UNITED STATES OF AMERICA
NUCLEAR REGULATORY COMMISSION

Amendment to License Nos.
DPR-24 and DPR-27
(Increase Spent Fuel
Storage Capacity)

(Point Beach Nuclear Plant,)
Units 1 and 2))

APPLICANT'S ANSWERS TO INTERROGATORIES
PROPOUNDED BY INTERVENOR
ON SEPTEMBER 27, 1978

Figure 1

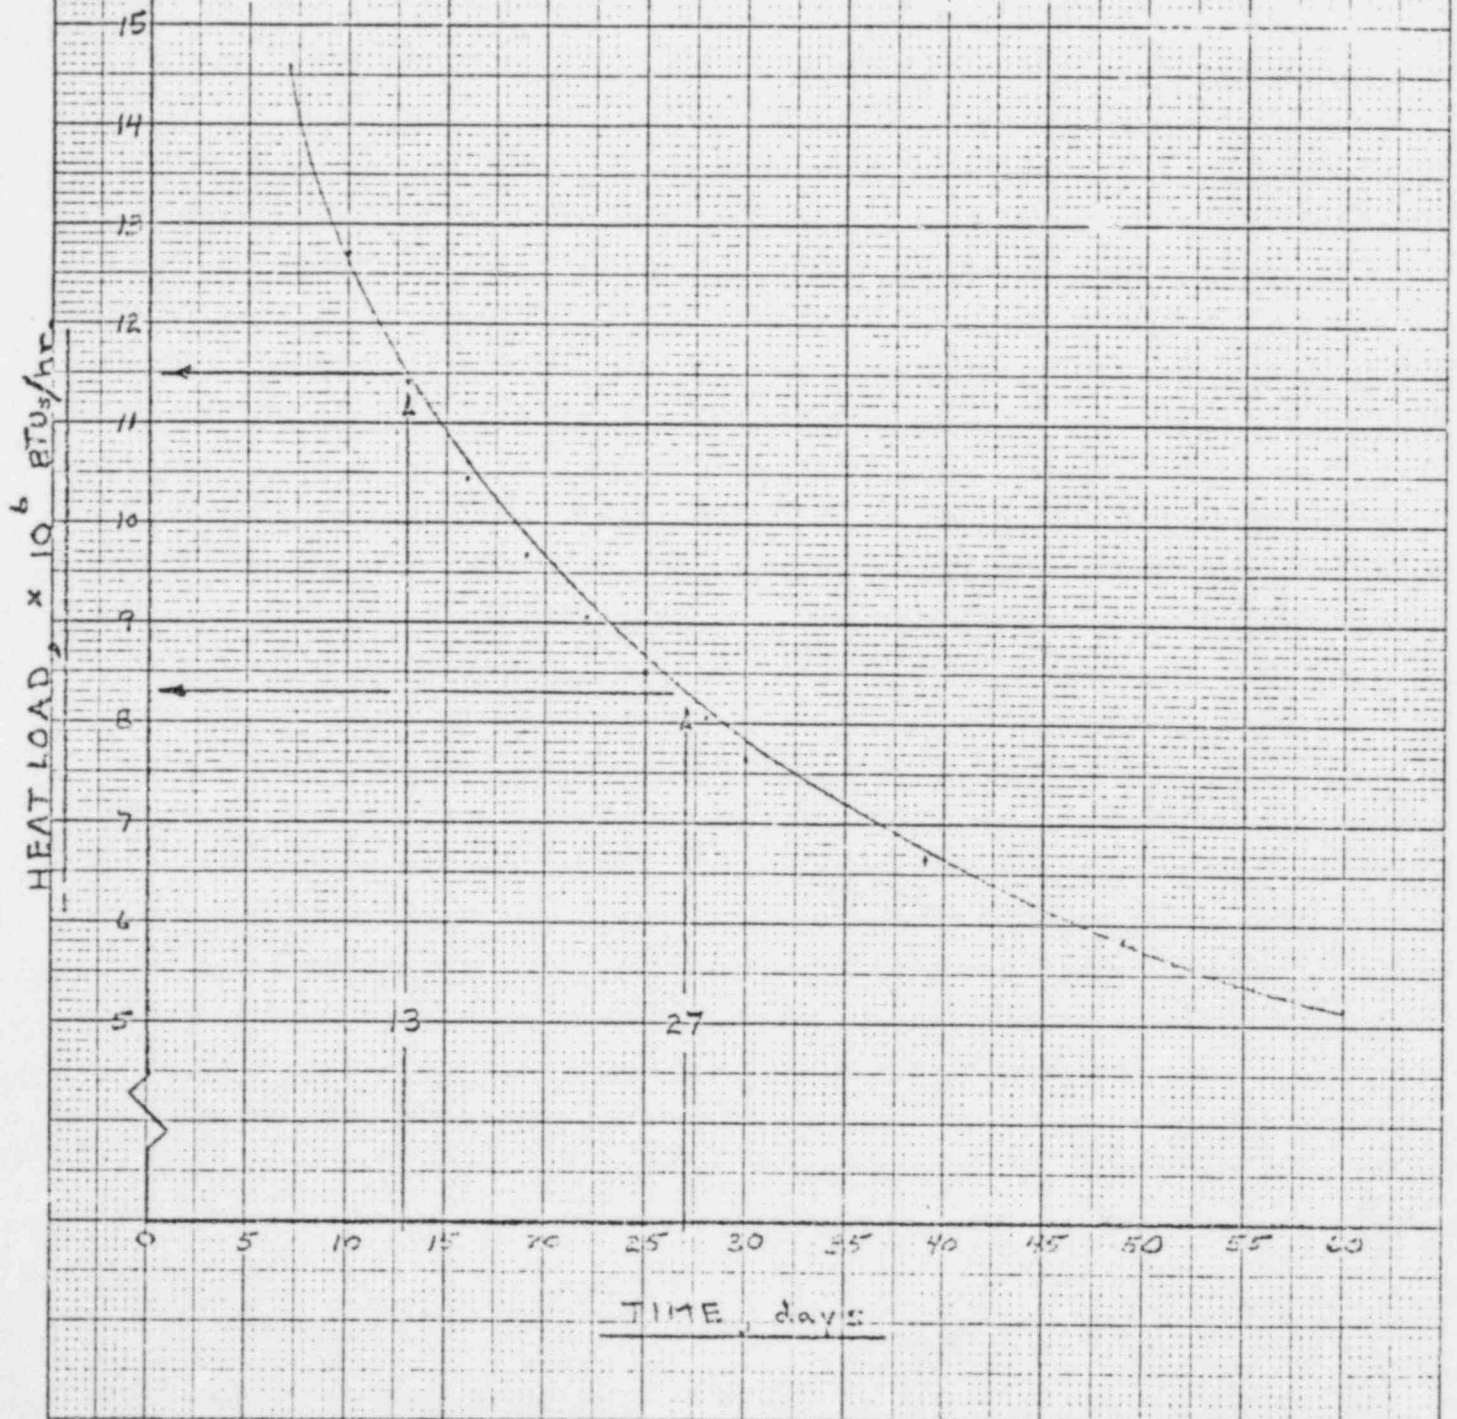
Predict the maximum temperature and heat load to the spent fuel pool in the event both cores must be unloaded into the filled spent fuel pool. Discuss the result of pump failures in this situation.

In order to evaluate the pool water temperature, it is first necessary to establish a time sequence of events and calculate the total heat load in the pool. The computer program identified in Section 4.2 of Attachment A to the application has been utilized to develop the heat loads for this situation. Figure 1 attached is a plot of the decay heat for a full core unload as a function of time after reactor shutdown.

The heat load that would be in the spent fuel pool is established as follows, assuming that thirteen days are required to unload a core and that the cores are unloaded sequentially with one day pause between unloadings:

a.	decay heat from second core unload 13 days after shutdown of reactor from Figure 1.	11.5×10^6 BTUs/hr
b.	remaining decay heat from first core unload 27 days after shutdown of reactor (13 days for unloading the first reactor, 1 day pause, 13 days for unloading the second reactor; from Figure 1).	8.3×10^6 BTUs/hr
c.	residual decay heat from 1260 in-storage assemblies (use 1280 assembly line from Table 4-1 of Attachment A to the application - no further decay accounted for)	9.38×10^6 BTUs/hr
Total decay heat load in pool		29.18×10^6 BTUs/hr

FIGURE 2

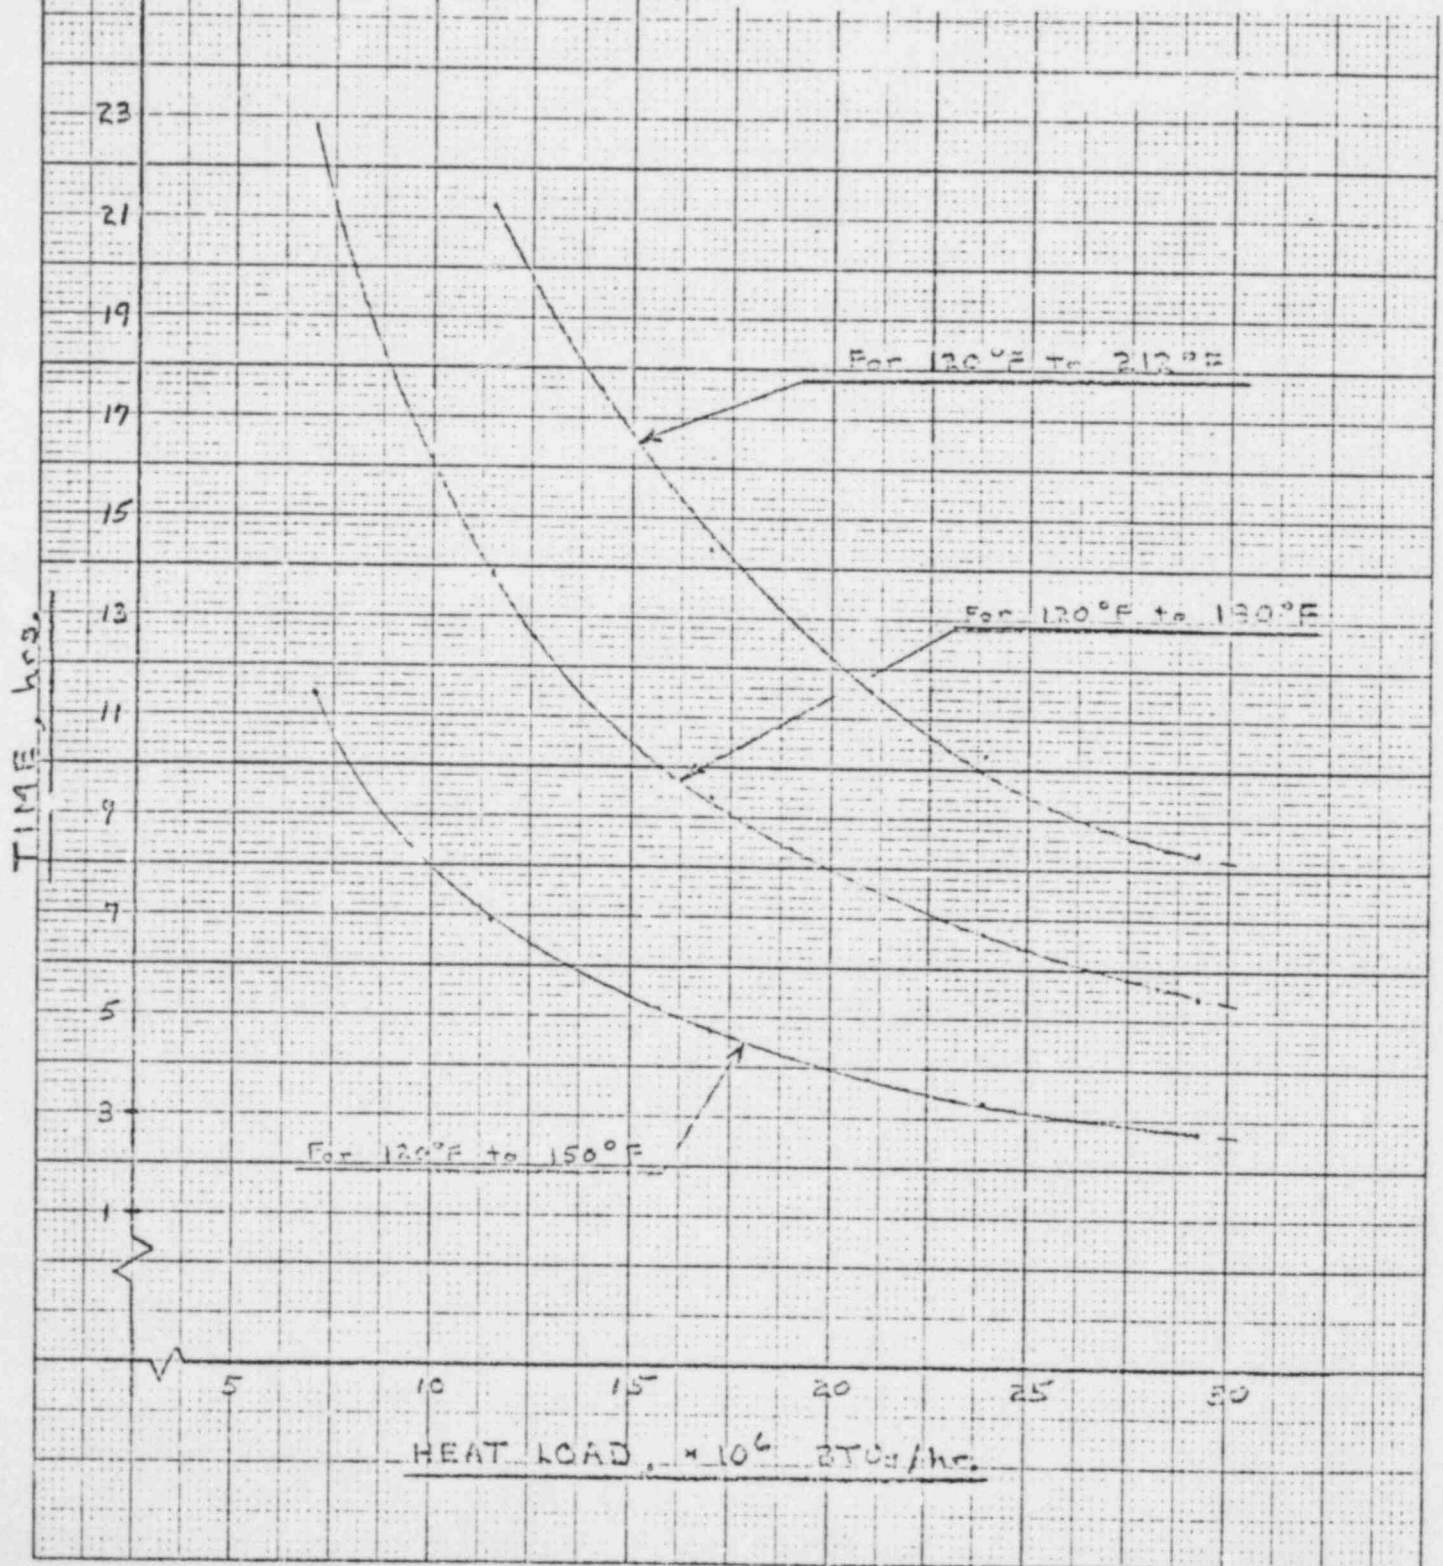
What would be the maximum spent fuel pool coolant water temperature if the pool's racks were filled to capacity (except spaces left open for emergency core offload needs) and both coolant pumps failed?

The time required to heat up the PBNP spent fuel pool for various heat loads at three different temperature increases is shown in Figure 2.

The results in Figure 2 are conservative because no credit is taken for evaporative cooling from the pool surface or for the heat capacity of other items in contact with the pool water (the pool steel liner, storage racks, and the metal in the stored spent fuel assemblies). Thus, the actual time required to heat up the volume of pool water would be longer than the calculated value.

Assuming both pumps fail and that one of the two cooling trains can be placed back into operation in less than five hours, then the maximum pool water temperature would be less than 150°F. This is shown in Figure 2 of the response to Interrogatory 3a.1. The resulting temperature for other time periods for placing one cooling train back into operation can also be obtained from Figure 2.
